ADDENDUM NO. 1
TO
CONTRACT DOCUMENTS
AND
TECHNICAL SPECIFICATIONS
FOR
VILLAGE OF WOODBURY BUILDING DEPARTMENT,
HIGHLAND MILLS, NY 10930

LAN Job #4.1365.07

January 07, 2021

1
A2.01
Proposed Floor Plan
1/4" = 1'-0"

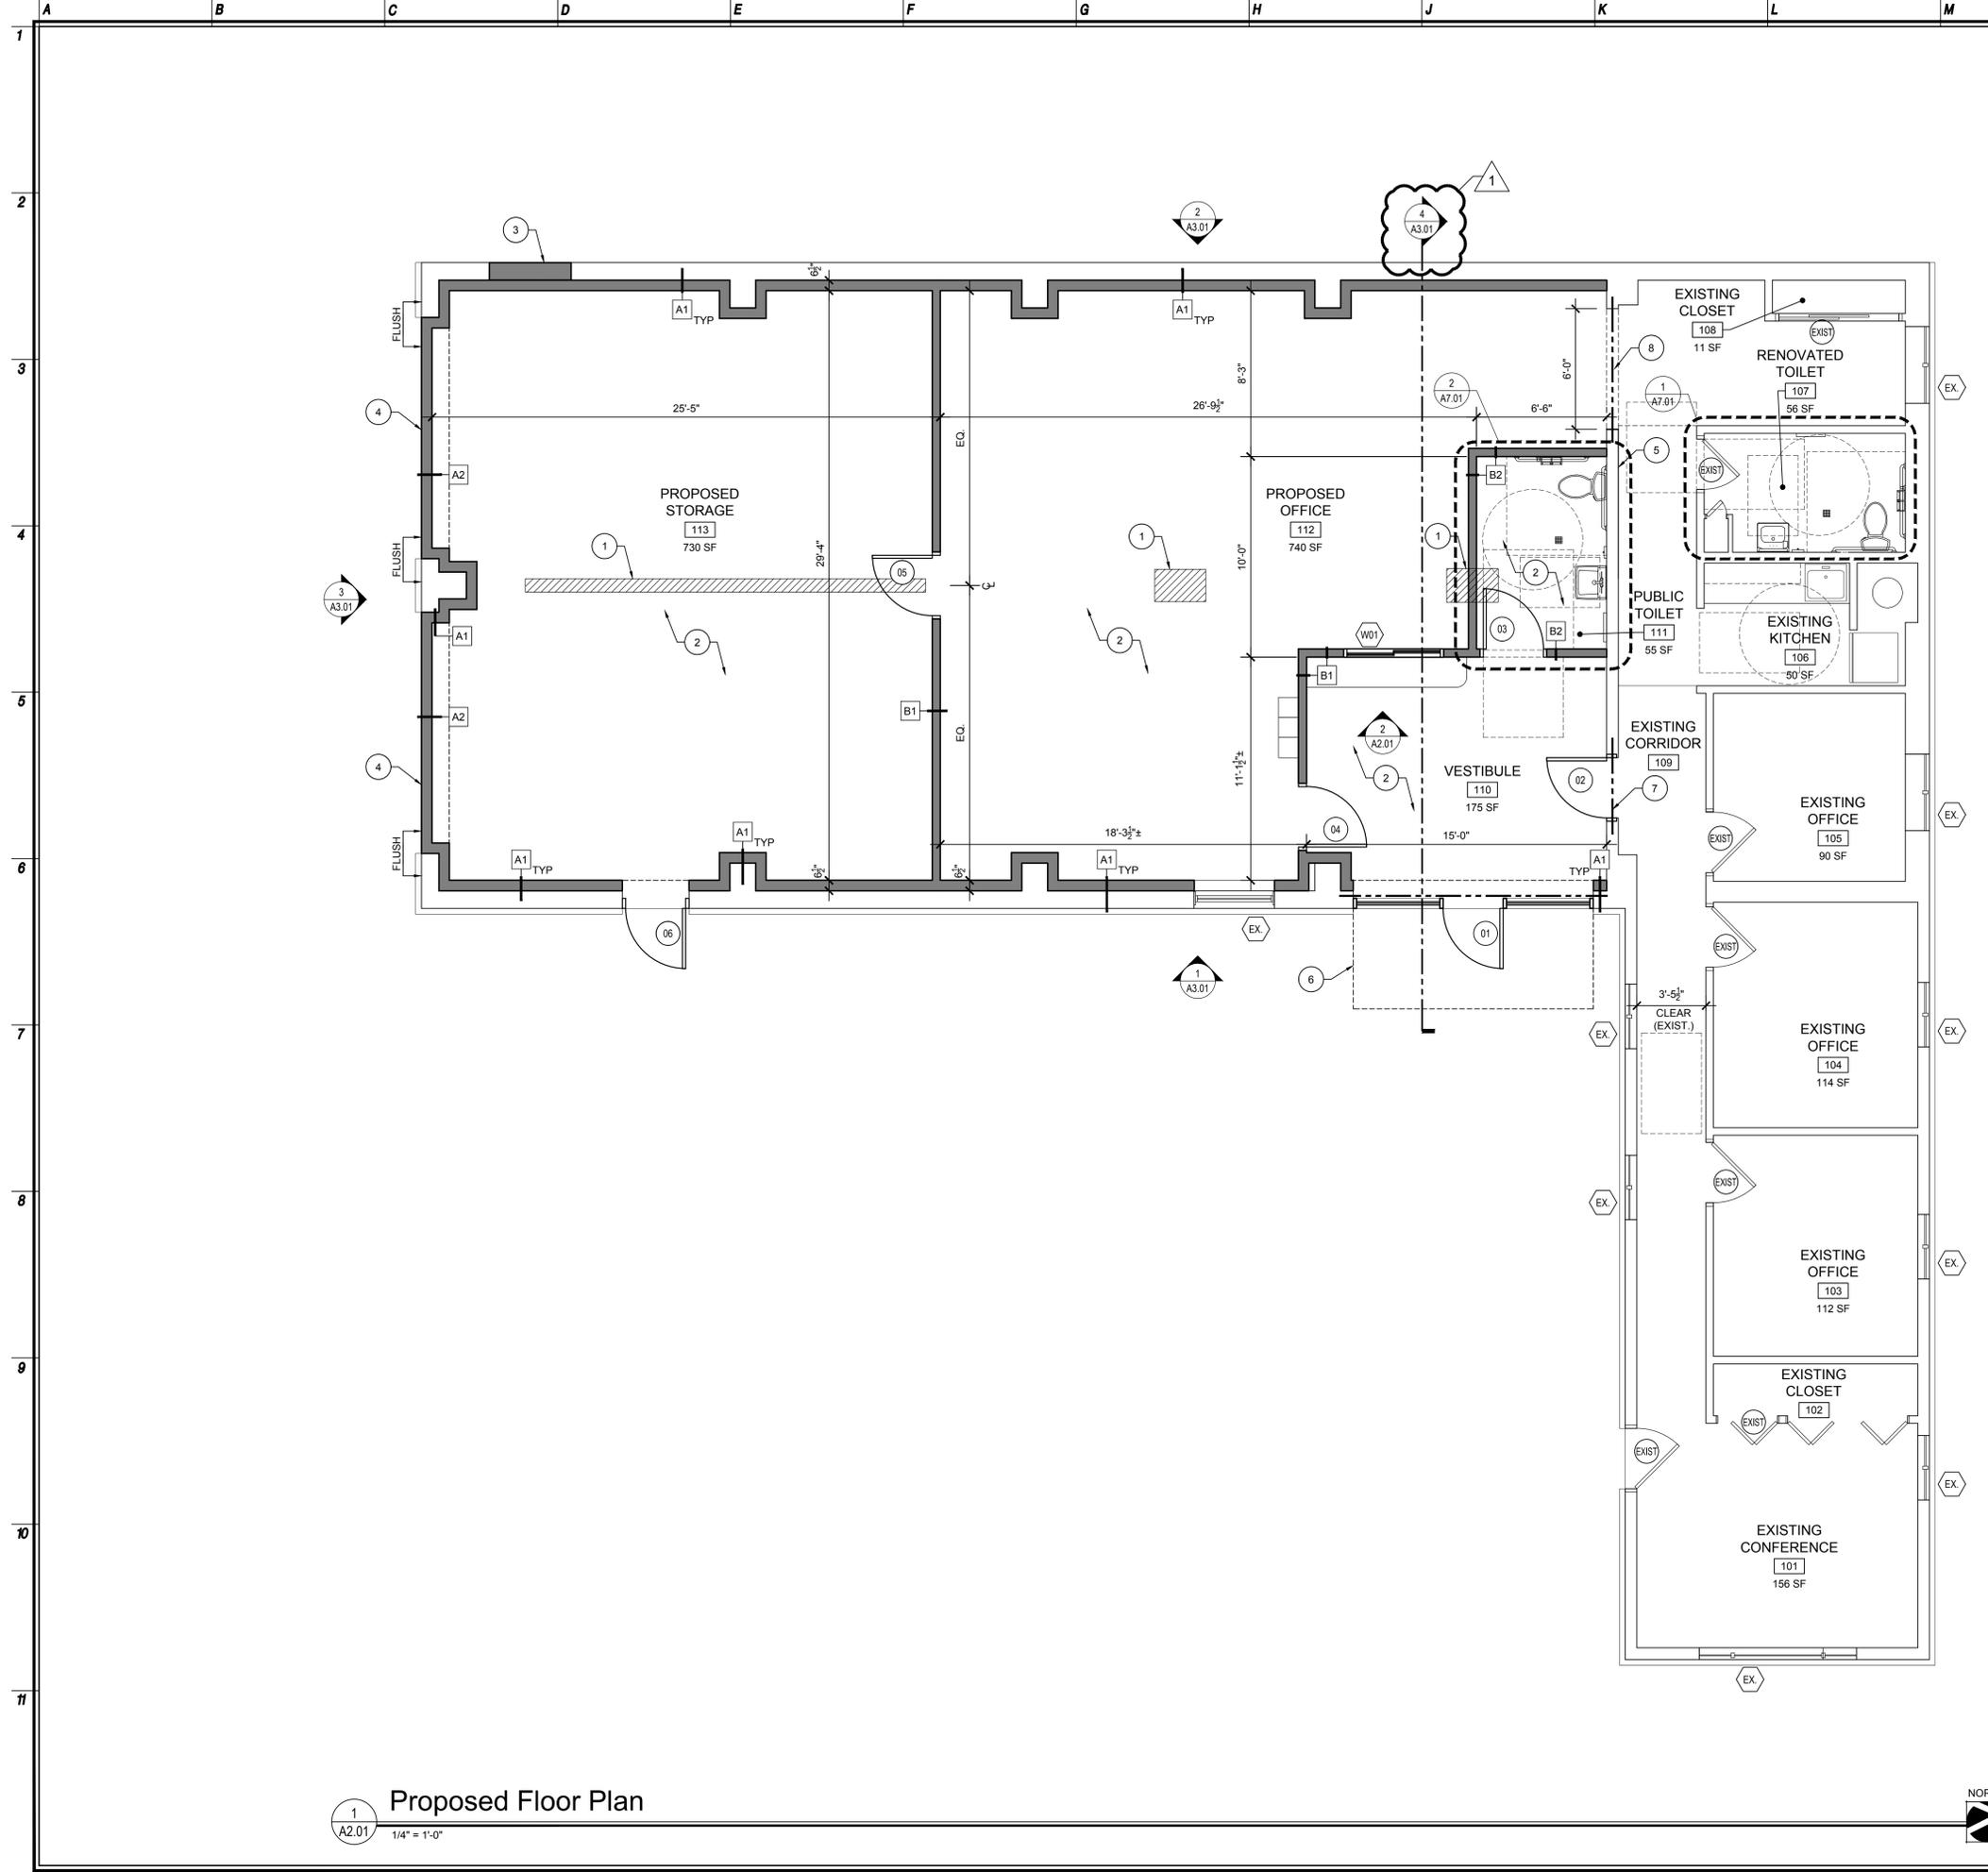
4. A2.01 – Service Window "W01" Is the entire window to be provided or just the shelf & bracket as noted (9 & 10 – A2.01)? If yes, please provide spec and size.

Response: The window is part of the scope of work. The window shall be a frameless 4'-0" x 4'-0" pass-thru window. Refer to attached revised sheet A2.01 for additional information.

- CONTRACTOR SHALL FURNISH AND INSTALL FRAMELESS PASS-THRU WINDOW. WINDOW MODEL SHALL BE "SH4848XXA" AS MANUFACTURED BY "C.R. LAURENCE CO., INC.". FINISH SHALL BE "SATIN ANODIZED." PANEL CONFIGURATION SHALL BE "XX." CONTRACTOR SHALL INSTALL PER MANUFACTURER'S INSTALLATION INSTRUCTIONS.
